Mr. John F. Stolz, Chief
Light Water Reactors Branch No. 1
Division of Project Management
U. S. Nuclear Regulatory Commission
Washington, D. C. 20555Re: Docket No. 50-275-OL
Docket No. 50-323-OL
Diablo Canyon Units 1 & 2

Enclosed in support of our operating license application are responses to informal questions 1 through 10 transmitted to PG&E in an August 4, 1978 memorandum on the subject of seismic qualifications.

This package contains non-proprietary responses to informal questions 1 through 10 transmitted to PGandE in an August 4, 1978 memorandum on the subject of Seismic Qualifications.

FIGURE 5

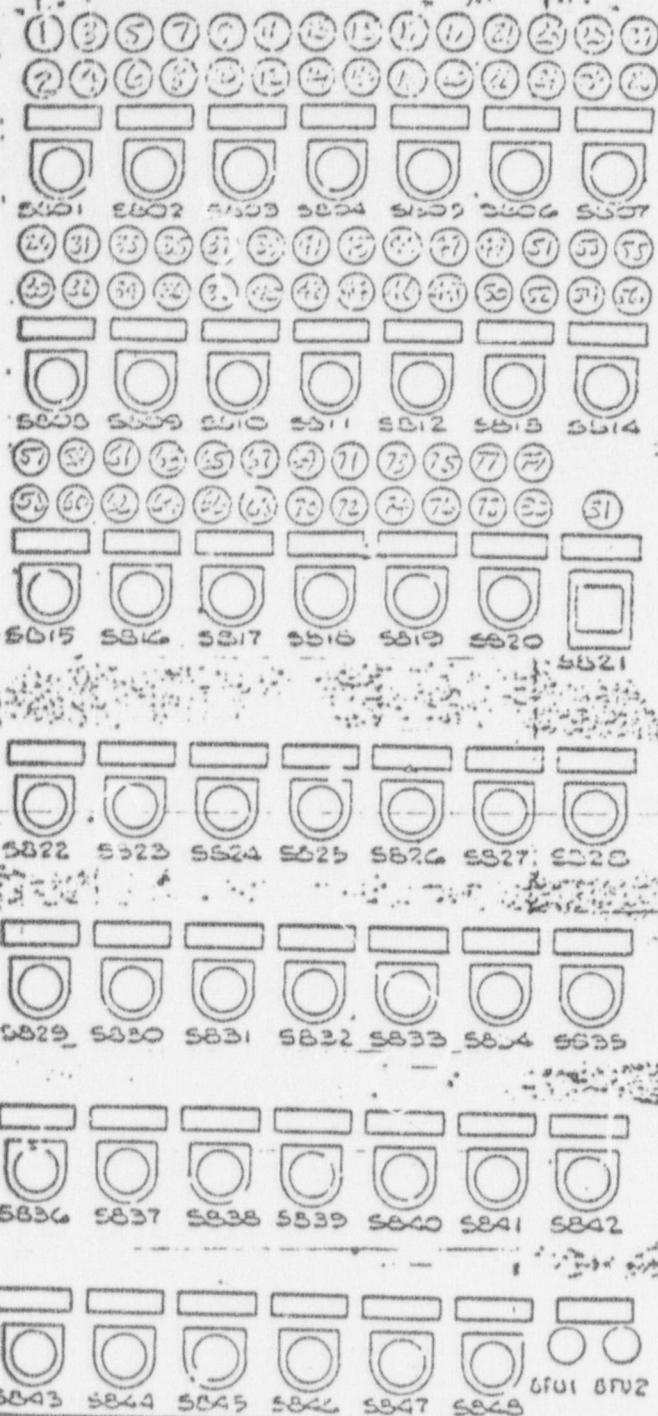
Provide electrical schematic diagrams of the test cabinet circuitry, describe the test set up, and identify the selected relays, switches, and components monitored during testing. Justify the seismic adequacy of relays, switches, and components that were not monitored during seismic testing.

Figure 4 shows the electrical test setup for monitoring selected switches, relays, and resistor-light-diode combinations of the Safeguards Test Cabinet during its seismic test. You will note that normally open and normally closed contacts of switches S804, S807, S818 and S821 were monitored, as were normally open and normally closed contacts of relays K801, K804, K811, K821 and K822. Two light-diode combinations, DS8038 and DS8040 were also monitored for continuity. Component location is shown in Figure 5.

Switches located in the top row (middle and side) and 3rd row (middle) were monitored. Relays located in the top row (side and middle), 2nd row (middle) and bottom row (side) were monitored.

The switches, relays and resistor-light-diode combinations that were not monitored during the seismic tests are identical to the ones that were

monitored, therefore are considered seismically adequate. Note that the locations of the components monitored are in areas of expected highest acceleration, i.e., middle of panel, top of panel.
